# PLANNING & ZONING COMMISSION
## City Hall Board Room
June 18, 2025 at 10:00 AM

**RE:** **Application for a Site Plan: Circle K , Mount Dora Groves South PUD (Project Name)**, 19110 US Highway 441, Mount Dora (Site Address); Andrew J. Hupp, One Oak MD Groves, LLC (Property Owner); Ryan Hileman, Bohler Engineering Fl, LLC (Applicant and Engineer); Kevin Aust, Bohler Engineering Fl, LLC (Landscape Architect); Rashmi Mehadia, AIA, RDC (Architect).
**Project No. SP25-01**

# Development Review Committee Response Sheet

RE: C Store Mount Dora (Circle K) – Site Plan (Project No.: SP25-01)
One Oak Mount Dora Groves Development
Second Review

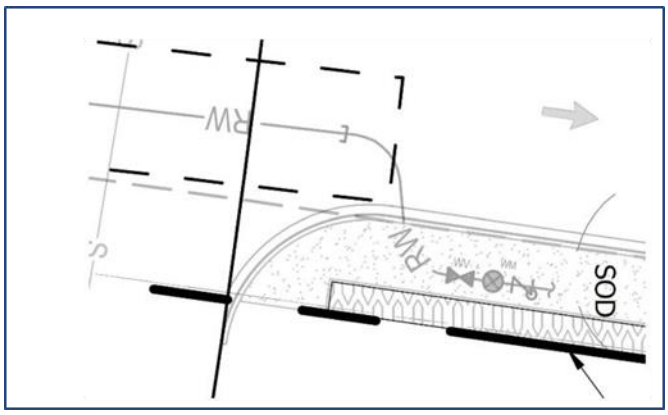
1. *Sheets C-501 and C-701 – "RW" reclaim water shows the backflow and meter connected. This is fine but change the naming on the drawing to avoid confusion. It is shown as "WV" and "WM" which is the designation for Potable appurtenances.*

**RESPONSE: Reclaim water valve and meter naming designation have been updated to show as "RWV" and "RWM" to avoid confusion. Please refer to the updated Civil and Landscape Plans.**

## FRONT ELEVATION (NORTH)
1/16" = 1'-0"

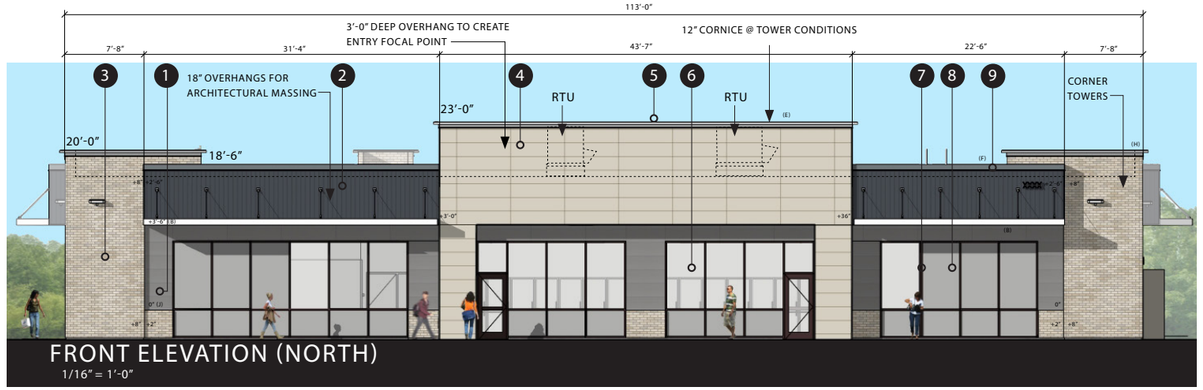
2. **Comment:** ***It appears that the covered walkways on the front (north) elevations are less than 6' wide and cover less than 50% of the façade length as well.***

The front elevation is approximately 2,290 SF and proposes approximately 450 SF of windows which is only 20% of the wall space and does not provide a covered walkway. Please revise the elevations to demonstrate compliance with this provision. The western elevation will also need to demonstrate compliance with this provision.

Revise the elevations to include projections and recesses on the front (northern) elevation.

*Revise the elevations to include projections and recesses on the front (northern) elevation.*

**rdc Response:** Based on comment received, the front elevation now proposes the 2'-6" extension of the overhangs and 3'-6" extension of the awnings to provide cover walkway, which now mirrors the length of the overhang. In addition, the front façade now has a total coverage percentage of 84%. Please refer to "Front Elevation (North)" on sheet three (3) – 'C-Store Elevations' for architectural updates. In addition to the elevations refer to the added sheet 'C-Store Floor Plan' on sheet two (2) and "Awning & Canopy Detail" on sheet three (3) for walkway coverage and projections in façade. Please review sheets seven through nine (7-9) for additional information.

**RESPONSE:** **Based on comment received, the front elevation now proposes additional windows with a mix use of spandrel and insulated glass in order to provide a transparency percentage of 33%; due to the operational need of C-store, equipment can not be relocated and creates the need for spandrel glass. Also included in the additions are two 3' deep pilaster to further insinuate the C-store's covered entrance and awnings to allow more coverage of the walkways in front of C-store. The left western elevation can not achieve a 33% transparency due to the operational and utility needs for the C-store to be accommodated in a small footprint. we added an awning to allow coverage to the side walk way of C-store. Please refer to "Front Elevation (North)" and "Left Elevation (West)" on sheet three (3) – 'C-Store Elevations' for architectural updates. In addition to the elevations refer to the added 'C-Store Floor Plan' on sheet two (2) for walkway coverage and projections in façade. Please review sheets seven through nine (7-9) for additional information.**

**RESPONSE:** **Acknowledged. Please refer to "Front Elevation (North)" on sheet three (3) – 'C-Store Elevations' and sheet two (2) – 'C-Store Floor Plan' where two 3' deep pilaster are proposed at the central tower of C-store and reforms the front facades horizontal length. Please review sheets seven through nine (7-9) for updated perspective views.**

FRONT ELEVATION
1/16″ = 1′-0″

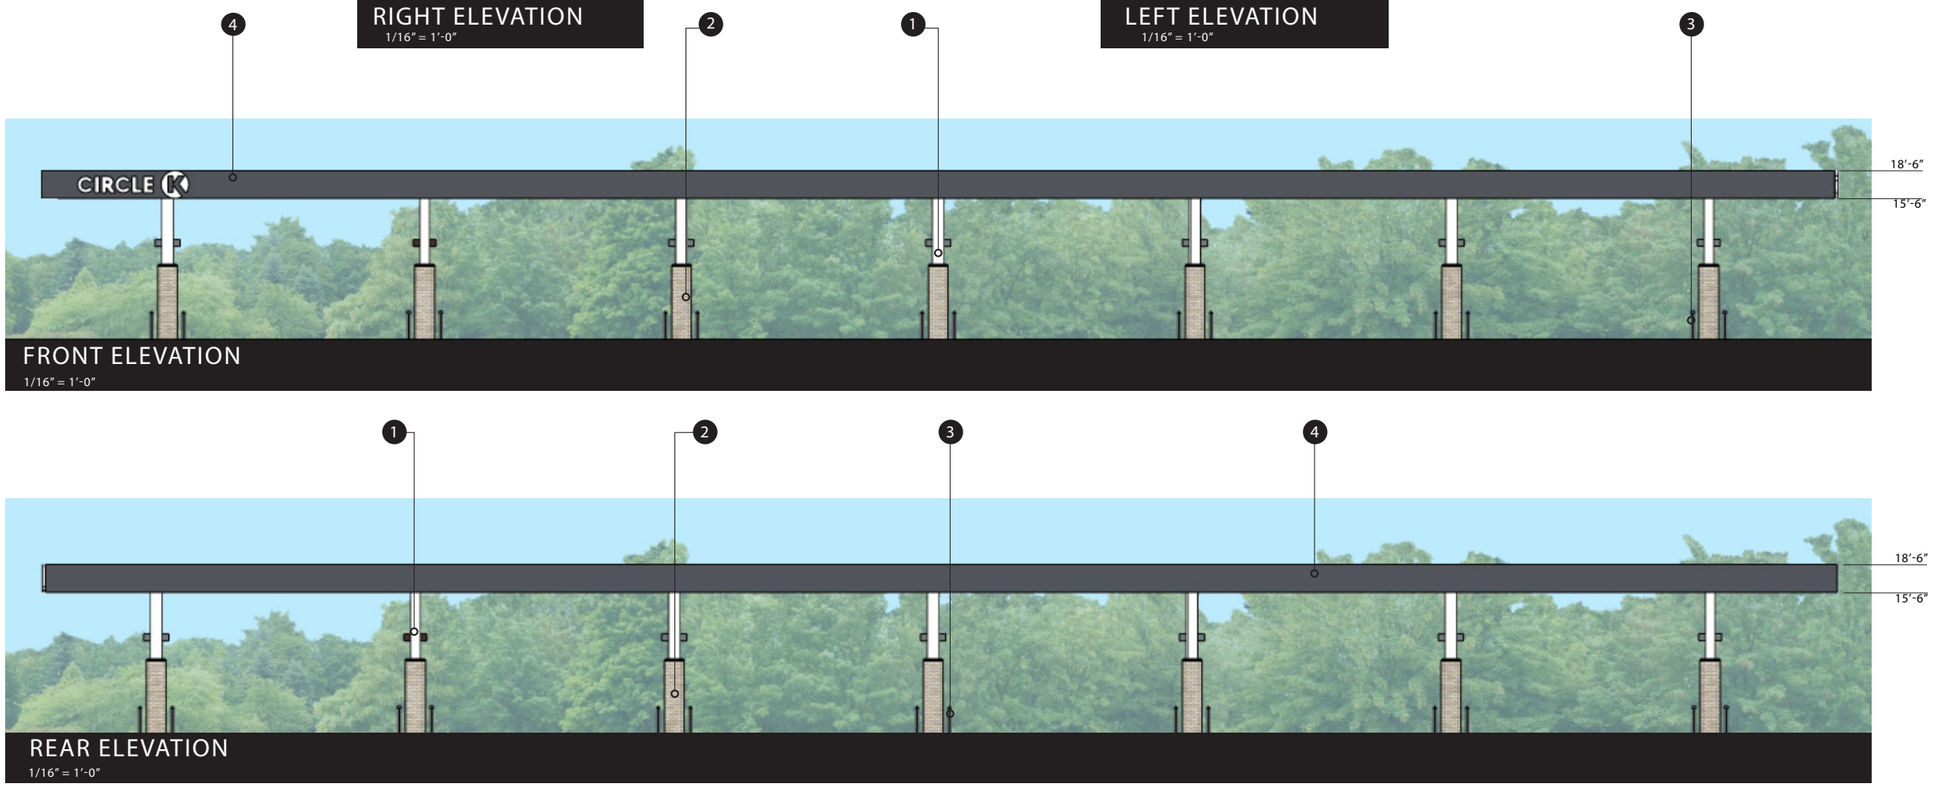
3. Building Elevations: Corporate colors or colors used in the marketing of the business occupying the space which are not earth tone shall be calculated towards the allowable signage copy area (which commercial design standards are set forth in Exhibit C, Ord. #2022-57); This requirements is intended to provide corporates, franchises, and corporate chains the opportunities to use other exterior colors (other than earth tone), but these colors be considered signage for the purpose of this Ordinance; provided these provisions don't conflict with Florida Statutes Section 553.

*Please provide the square footage of corporate colors for signage calculation.*

**RESPONSE:** **Acknowledge. Please refer to "Front Elevation (North)" on sheet three (3) – 'C-Store Elevations' where store signage is removed, signage will be approved separately. Please review sheets seven through nine (7-9) for updated perspective views.**
